Sheet No. C0.0

Project Title:
EAST TOWN CROSSING PHASE 1

Project No.
2230752
Issue Set & Date:
PERMIT SUBMITTAL
11/20/2023

Sheet No.
C6.01

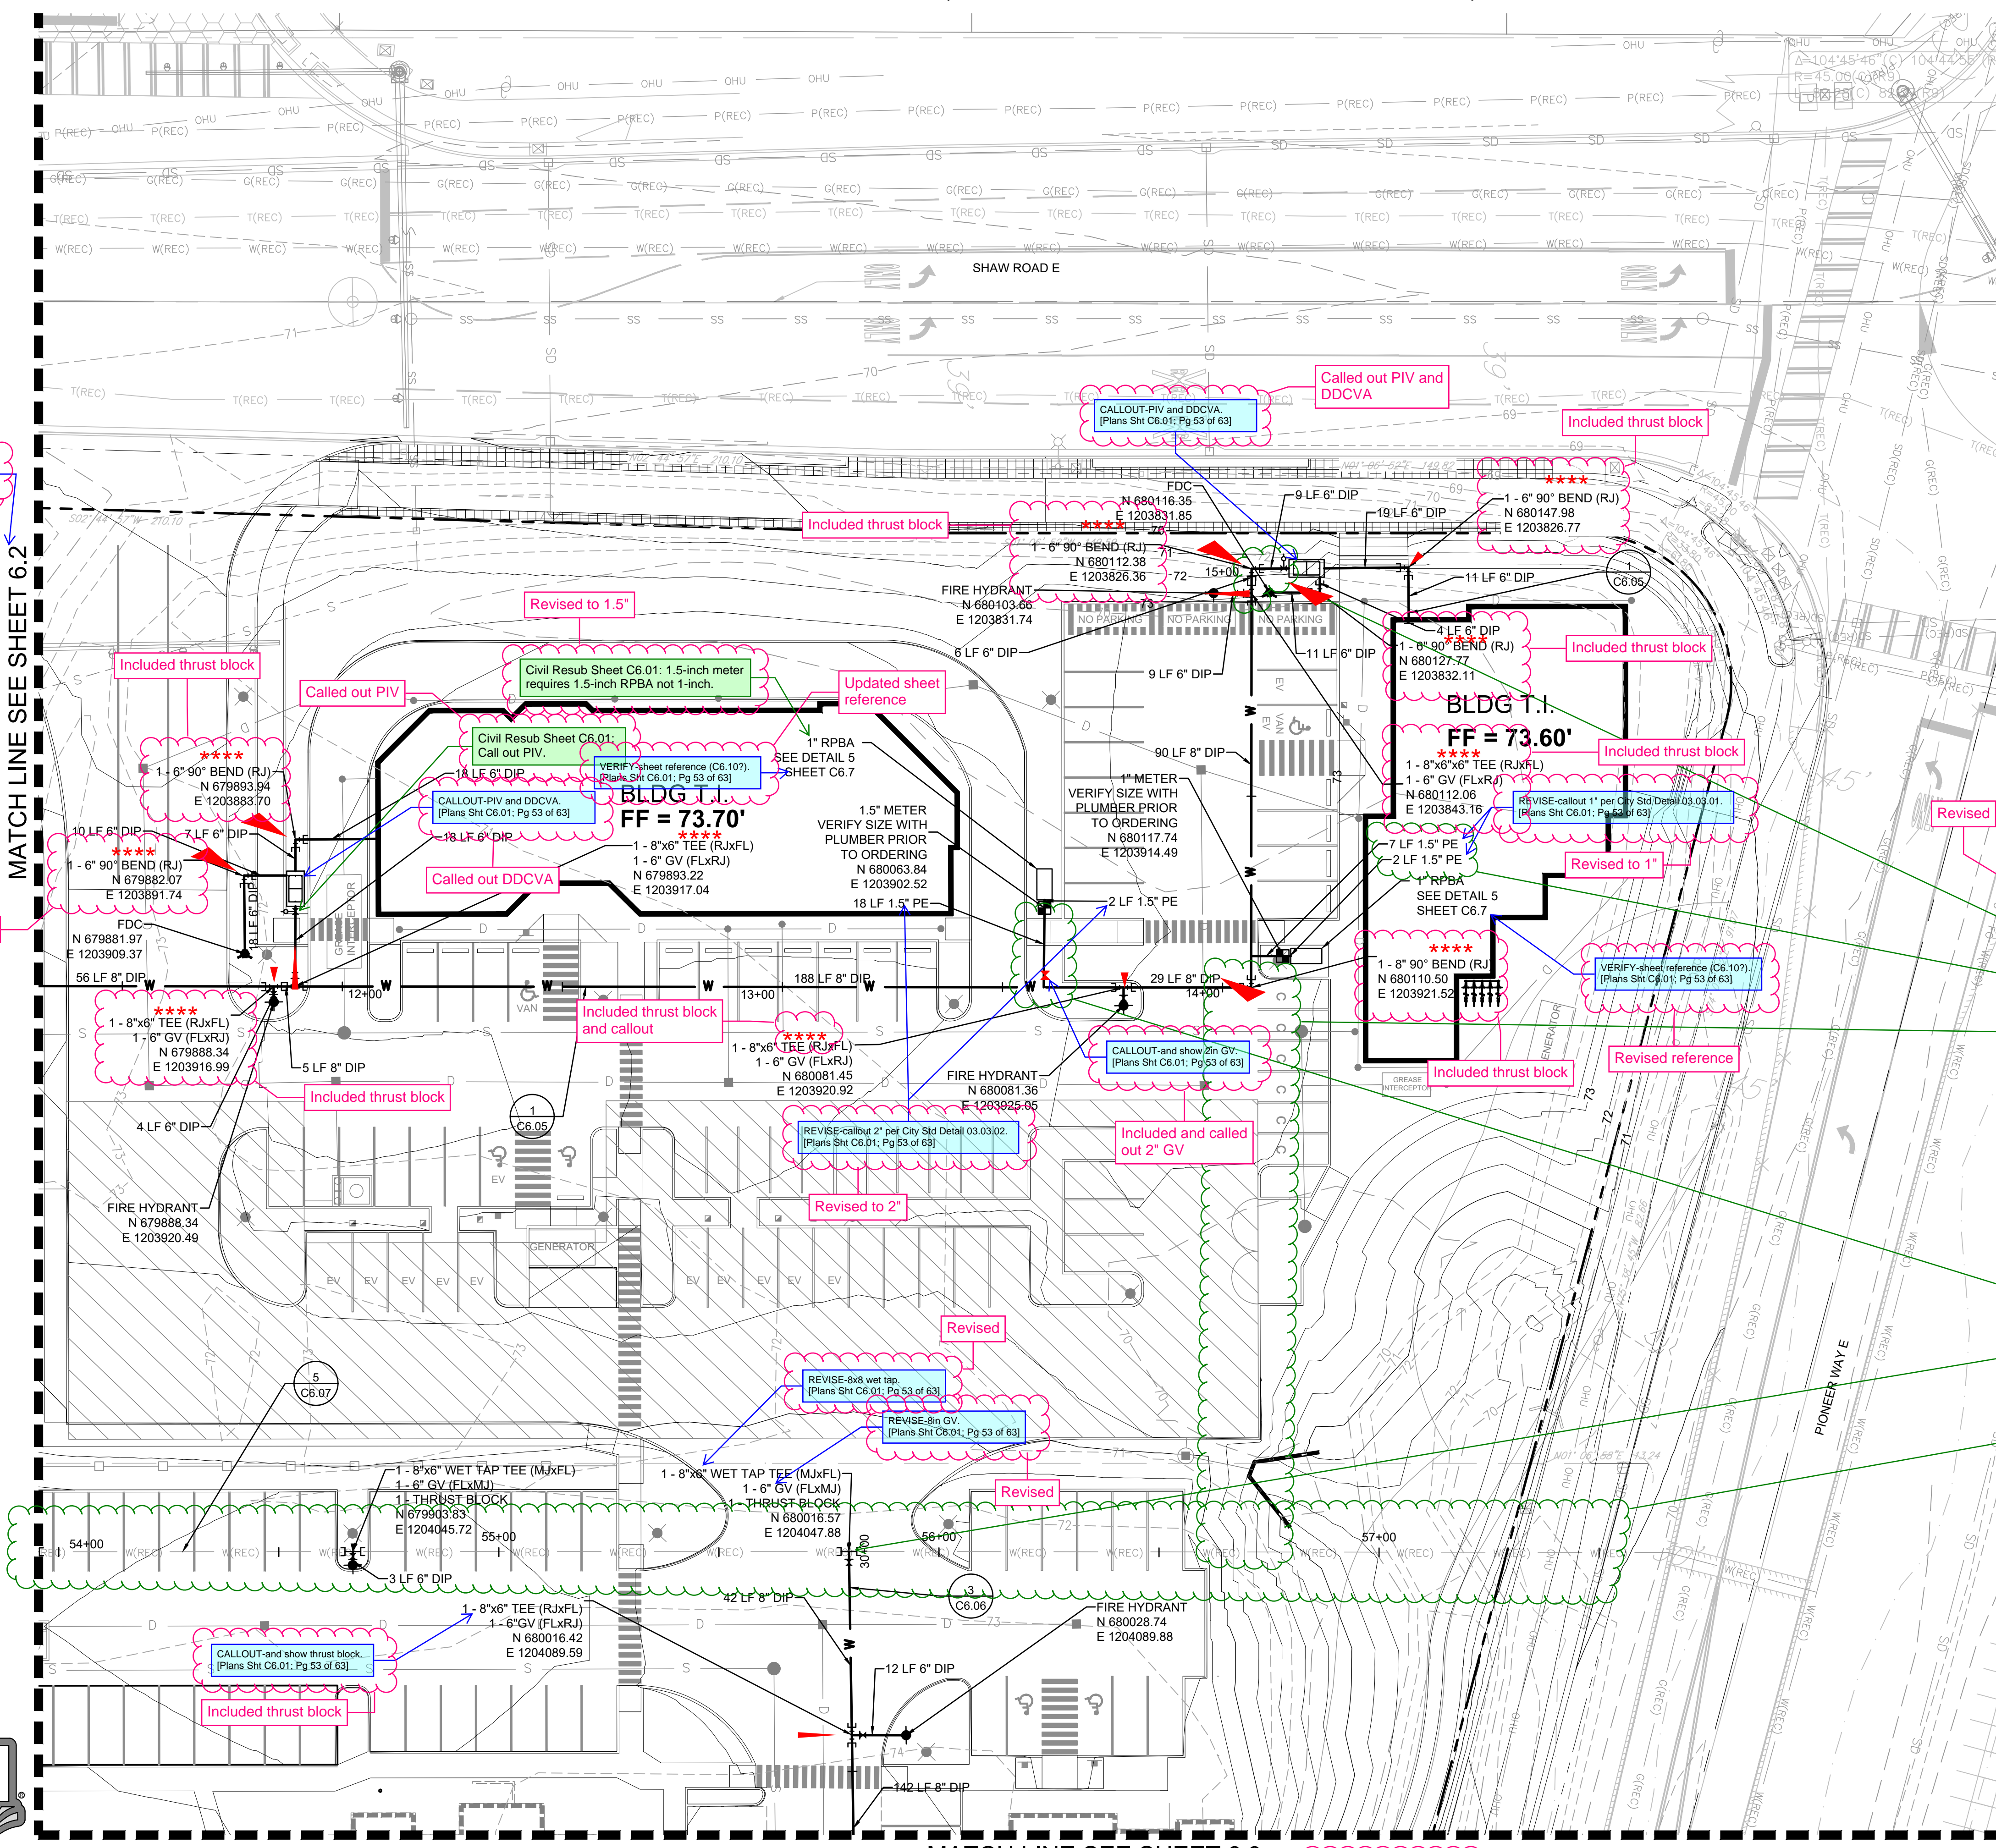
- Civil Resub Sheet C6.01: The hydrant tee should be called out as 8-inch by 8-inch by 6-inch FI tee. An 8-inch FI by MJ adapter to the east. An 8-inch by 6-inch FI reducer to the west. A 6-inch gate valve FI by MJ west of reducer. Call out PIV by fire vault.

- Civil Resub Sheet C6.01: 1-inch PE for 1-inch water service.
- Civil Resub Sheet C6.01: Fire flow will be reduced by not looping in the dead-end 8-inch water main runs.

- **** = CALLOUT-and show thrust block [Plans Sht C6.01; Pg 53 of 63]
- Civil Resub Sheet C6.01: Follow City standards. Call out 2-inch PE with 2-inch gate valves shown on plan set.
- Civil Resub Sheet C6.01: This tee will be an 8-inch by 8-inch wet tap with a stainless steel tapping sleeve and an 8-inch gate valve. Not 8-inch by 6-inch as called out.
- Civil Resub Sheet C6.01: The existing 8-inch water main through this project will be public and all other water lines will be private. Show and call out the public water easement on this plan set.

Updated
VERIFY-sheet Ref (C6.02)
[Plans Sht C6.01; Pg 53 of 63]

Updated
Civil Resub Sheet C6.01: 1.5-inch meter requires 1.5-inch RPBA not 1-inch.
Updated sheet reference
1" RPBA
SEE DETAIL 5
SHEET C6.7

Updated
Civil Resub Sheet C6.01: Call out PIV.
Callout PIV and DDCVA
[Plans Sht C6.01; Pg 53 of 63]

Updated
Civil Resub Sheet C6.01: Call out PIV and DDCVA.
[Plans Sht C6.01; Pg 53 of 63]

Updated
Civil Resub Sheet C6.01: Call out PIV and DDCVA.
[Plans Sht C6.01; Pg 53 of 63]

Updated
VERIFY-sheet Ref (C6.03)
[Plans Sht C6.01; Pg 53 of 63]

- Added note: Wet taps to existing water mains shall be accomplished through a tapping tee and tapping valve and shall be made by a city approved contractor. The tapping sleeve shall be Romac SST all stainless steel tapping sleeve or approved equal. A two-piece epoxy coated or ductile iron tapping sleeve may be used on ductile iron pipe, when the tap is smaller than the water main size i.e. 6-inch tap on 8-inch pipe. The City shall approve the time and location for these connections. [Plans Sht C6.01; Pg 53 of 63]

- Added note: If the project is utilizing a fire booster pump, the FDC must connect to the sprinkler system on the discharge side of the pump in accordance with NFPA regulations. [Plans Sht C6.01; Pg 53 of 63]

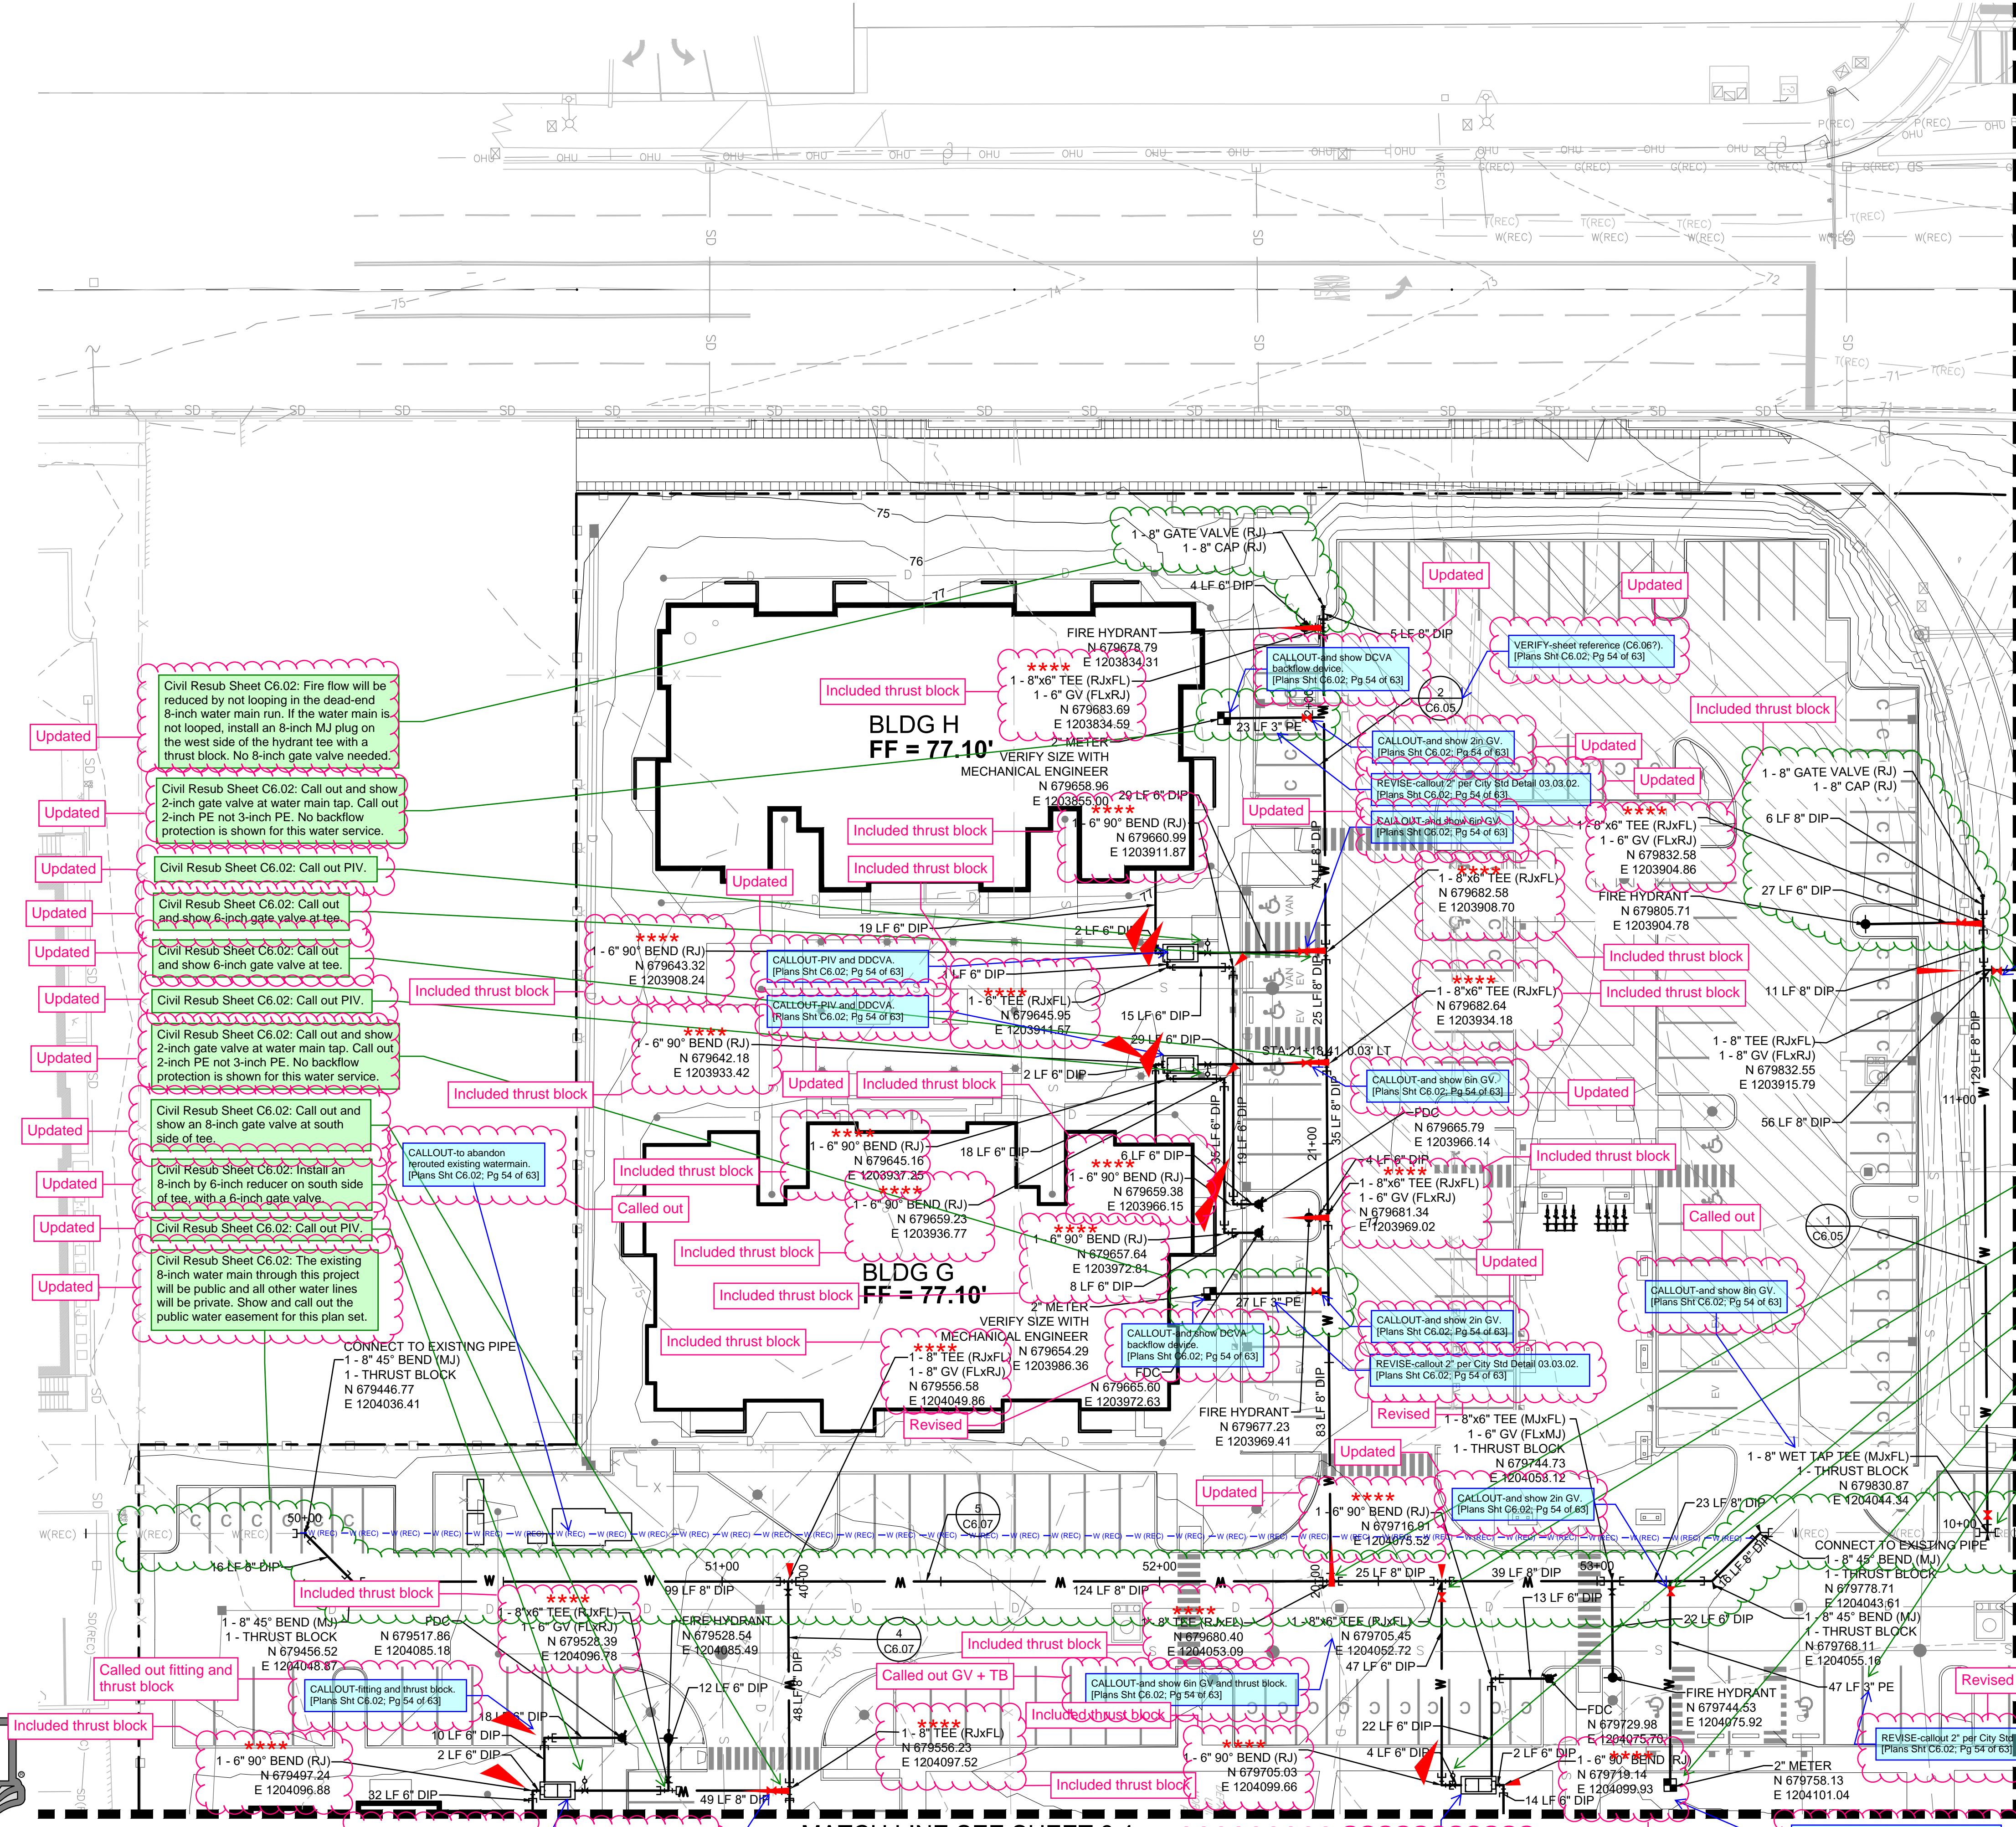
- Updated Civil Resub Sheet C6.02: Fire flow will be reduced by not looping in the dead-end 8-inch water main run. If the water main is not looped, install an 8-inch MJ plug on the west side of the hydrant tee with a thrust block. No 8-inch gate valve needed.

- Updated Civil Resub Sheet C6.02: Call out and show 2-inch gate valve at water main tap. Call out 2-inch PE not 3-inch PE. No backflow protection is shown for this water service.

- Updated Civil Resub Sheet C6.02: Call out PIV.
- Updated Civil Resub Sheet C6.02: Call out and show 6-inch gate valve at tee.
- Updated Civil Resub Sheet C6.02: Call out PIV.

- Updated Civil Resub Sheet C6.02: Call out and show 2-inch gate valve at water main tap. Call out 2-inch PE not 3-inch PE. No backflow protection is shown for this water service.

- Updated Civil Resub Sheet C6.02: Call out and show an 8-inch gate valve at south side of tee.
- Updated Civil Resub Sheet C6.02: Install an 8-inch by 6-inch reducer on south side of tee, with a 6-inch gate valve.

- Updated Civil Resub Sheet C6.02: Call out PIV.
- Updated Civil Resub Sheet C6.02: The existing 8-inch water main through this project will be public and all other water lines will be private. Show and call out the public water easement for this plan set.

ADD NOTE: Wet taps to existing water mains shall be accomplished through a tapping tee and tapping valve and shall be made by a city approved contractor. The tapping sleeve shall be Romex SST all stainless steel tapping sleeve or approved equal. A two-piece epoxy coated or ductile iron tapping sleeve may be used on ductile iron pipe, when the tap is smaller than the water main size i.e. 6-inch tap on 8-inch pipe. The City shall approve the time and location for these connections. [Plans Sht C6.02; Pg 54 of 63]

Civil Resub Sheet C6.02: Fire flow will be reduced by not looping in the dead-end 8-inch water main run. If the water main is not looped, install an 8-inch MJ plug on the west side of the hydrant tee with a thrust block. No 8-inch gate valve needed. Show the 6-inch gate valve for the hydrant. A fire hydrant run should be 20-feet or less in length. Move hydrant back in parking bump-out.

Civil Resub Sheet C6.02: Show 8-inch gate valve at tee.

Civil Resub Sheet C6.02: No line valves are called out on the public water main through this project. If any work needs to be done on this public main, all water to this complex will be off until work is completed. At a minimum, consider installing three 8-inch gate valves at this tee for better control. One 8-inch gate valve is required on the east side of this tee.

Civil Resub Sheet C6.02: Call out and show a 6-inch gate valve at this tee.

Civil Resub Sheet C6.02: Call out PIV.

Civil Resub Sheet C6.02: Call out and show 2-inch gate valve at water main tap.

Civil Resub Sheet C6.02: No backflow protection is shown for this water service.

Civil Resub Sheet C6.02: Call out 8-inch stainless steel tapping sleeve with gate valve. Show valve.

Civil Resub Sheet C6.02: Call out 2-inch PE, not 3-inch PE.

Civil Resub Sheet C6.02: Call out 8-inch stainless steel tapping sleeve with gate valve. Show valve.

Civil Resub Sheet C6.02: Call out 2-inch PE, not 3-inch PE.

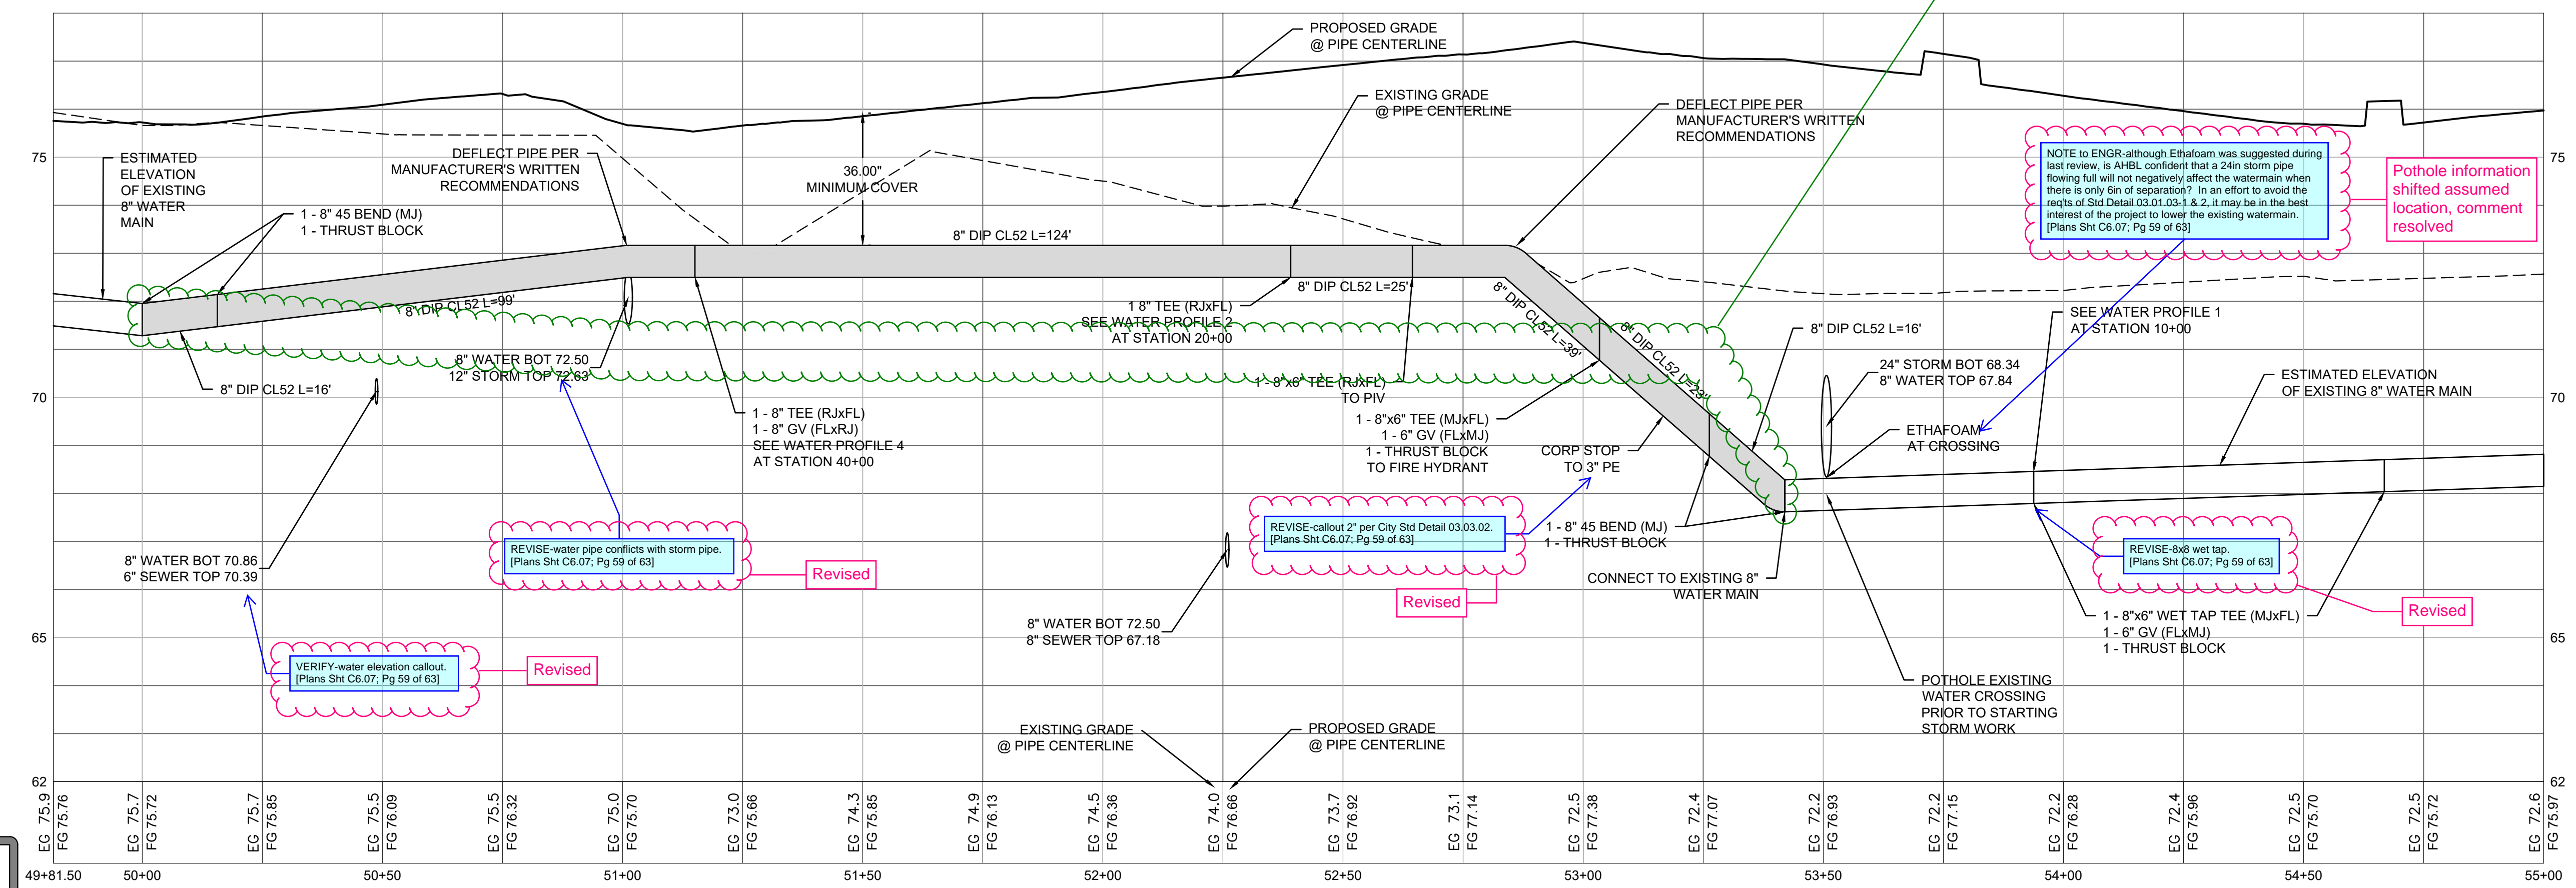
REVISE-callout 2" per City Std Detail 03.03.02 [Plans Sht C6.07, Pg 59 of 63]
